Addendum / Addenda

No./N^o
3

Project Description / Description de projet M-36 Kelvin Room Renovations		
Solicitation No./ No de sollicitation 13-22089	Project No./N ^o de projet 3876	W.O. No./N ^o d'ordre de travail
Departmental Representative / représentant ministériel Noel Fagan		Date December 10, 2013
<p>Notice: This addendum shall form part of the tender documents and all conditions shall apply and be read in conjunction with the original plans and specifications.</p>		<p>Nota: Cet addenda fait partie intégrale des dossiers d'appel d'offres; toutes les conditions énoncées doivent être lues et appliquées en conjonction avec les plans et les devis originaux.</p>

ADDENDUM #1
MODIFICATIONS TO ROOM 1100B

3876-A03

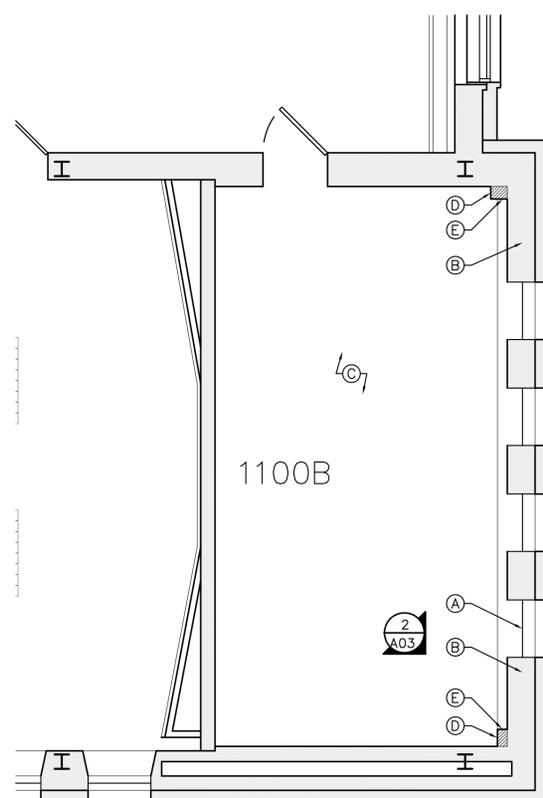
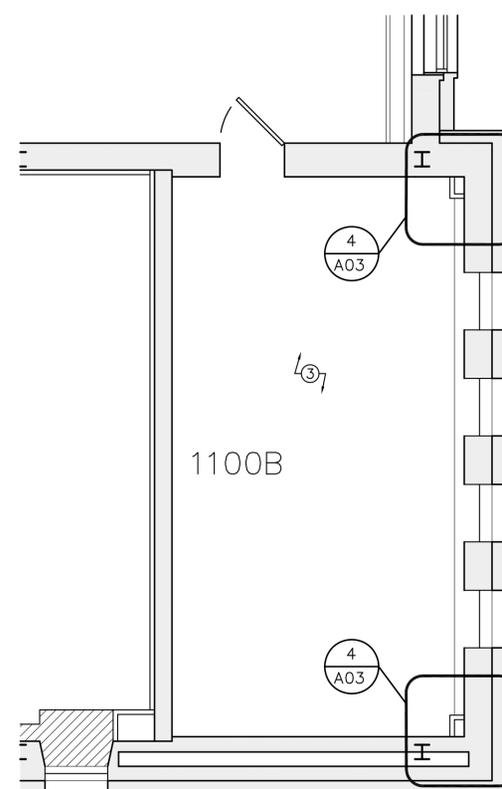
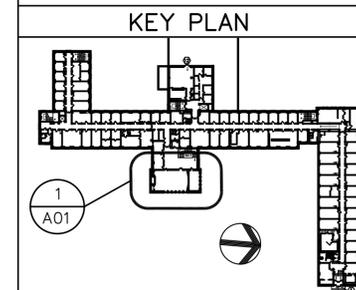
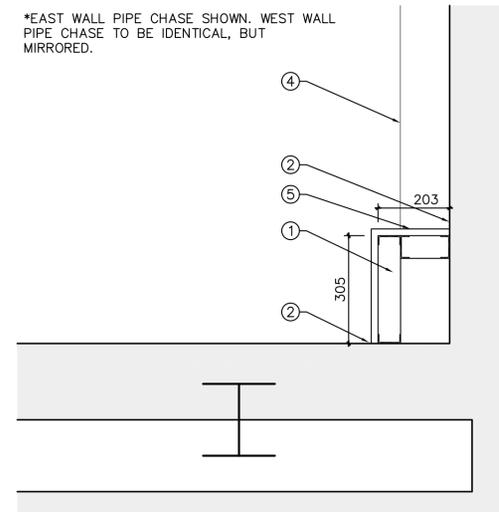
1. Add the attached drawing 3876-A03 to reflect work in room 1100B that is being added to the scope of the project.
2. Fill existing boxes for 2 floor receptacles that are being removed. New flooring to go over top.

6. In room 1100B, remove existing surface mounted receptacle and conduit as well as surface mounted conduit and box for telecom jacks in 2 locations to allow for wall repair. Re-install flush mounted receptacles and boxes for data wiring in new walls in same location. Refer to new architectural drawing 3876-A03 for both locations of wall repairs.

dwg.no. **3876-M02** dessin no.

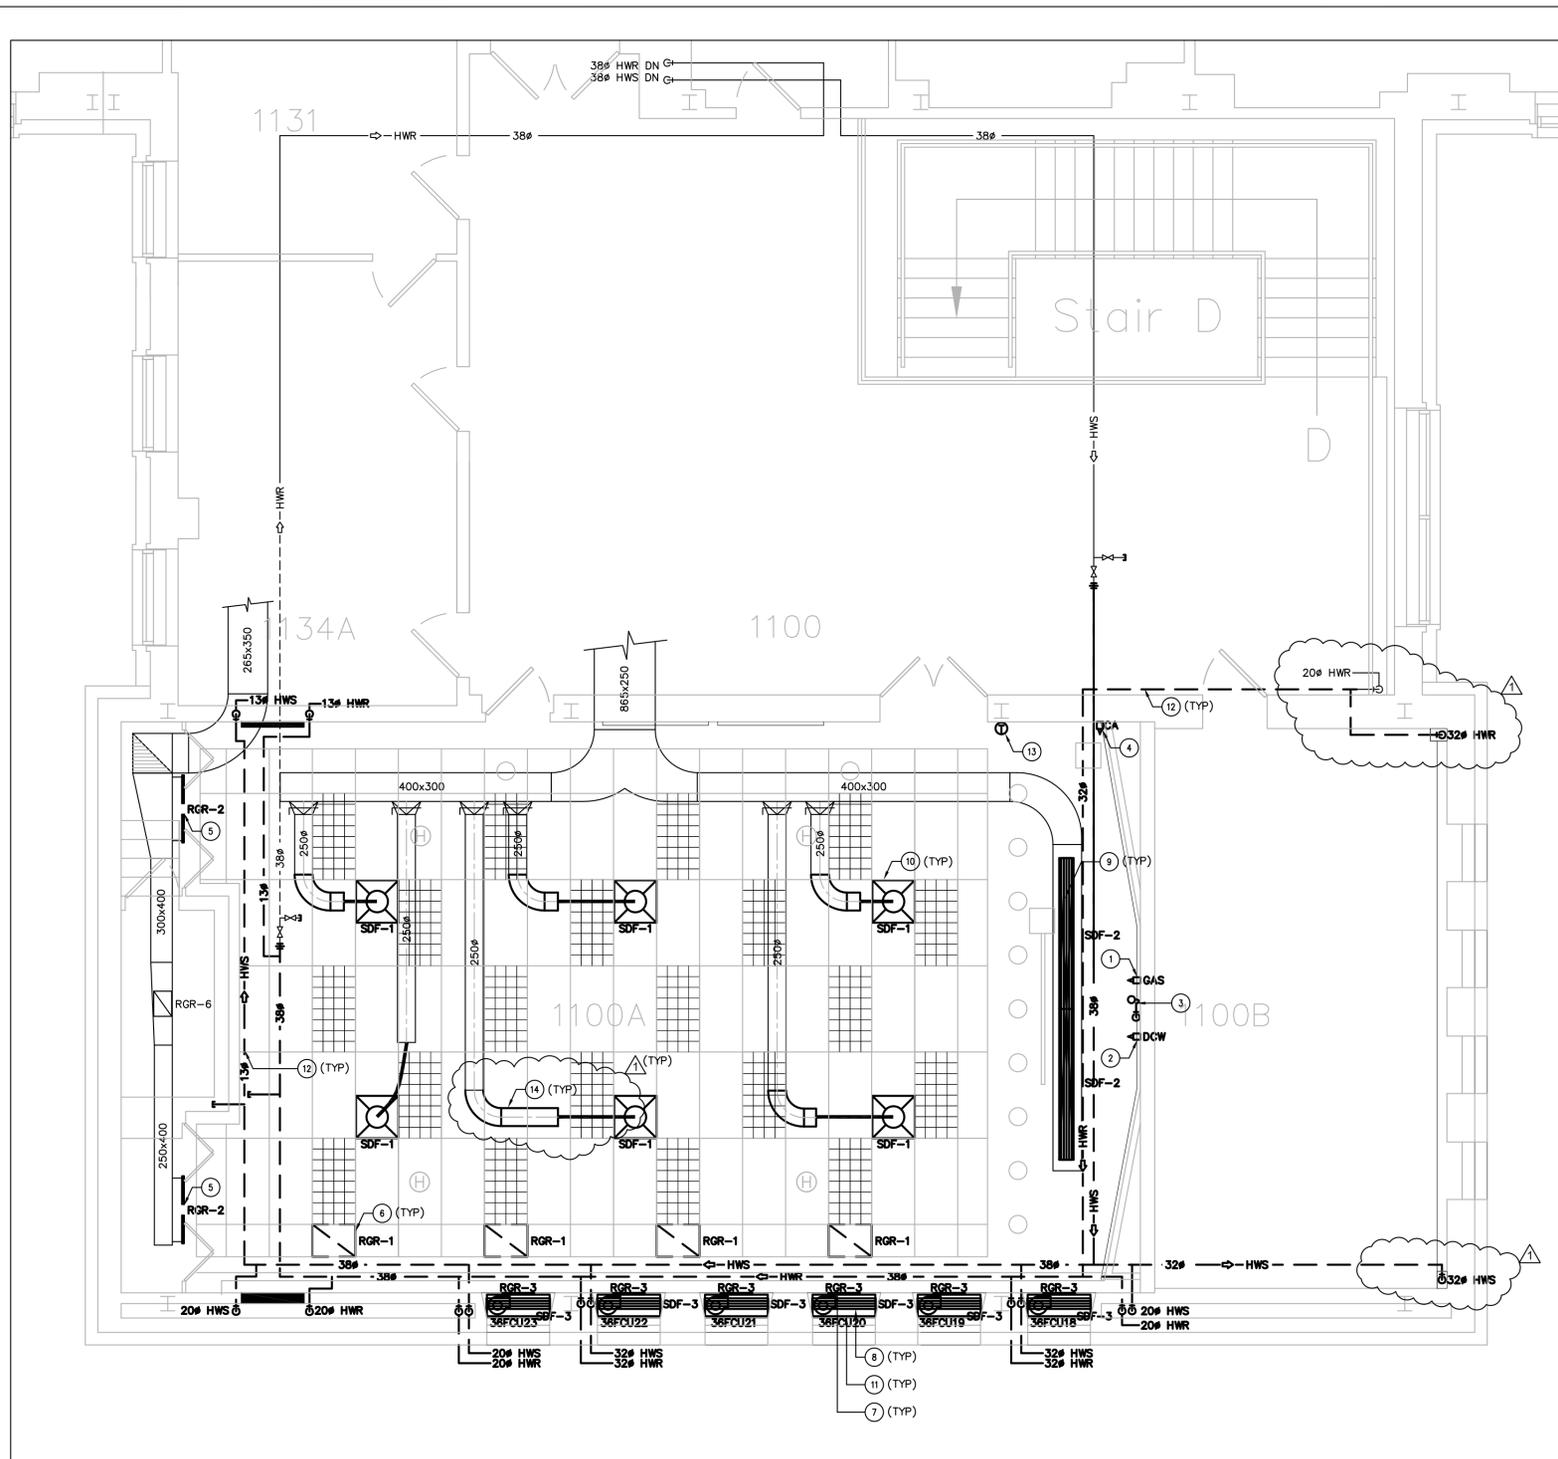
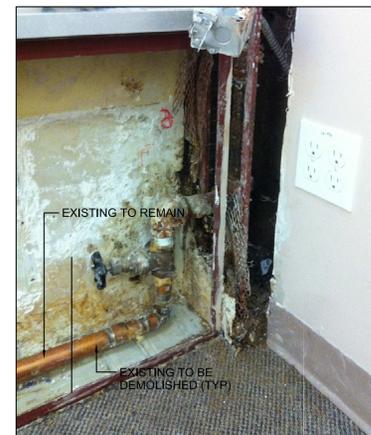
3. Replace drawings 3876-M02, 3876-M03 and 3876-M04 with the attached to reflect work in room 1100B that is being added to the scope of the project as well as clarify ductwork in room 1100A.
4. Remove the following specification sections from the specifications : 250112, 251001 and 251002.
5. Contact information for Direct Energy (now known as Airtron) :
Aaron Dobson
Account Executive - Services
Direct Energy Business Services
100-2935 Conroy Road, Ottawa, ON
Phone: 613-247-7938 Fax: 613-247-7990
Mobile: 613-203-1951
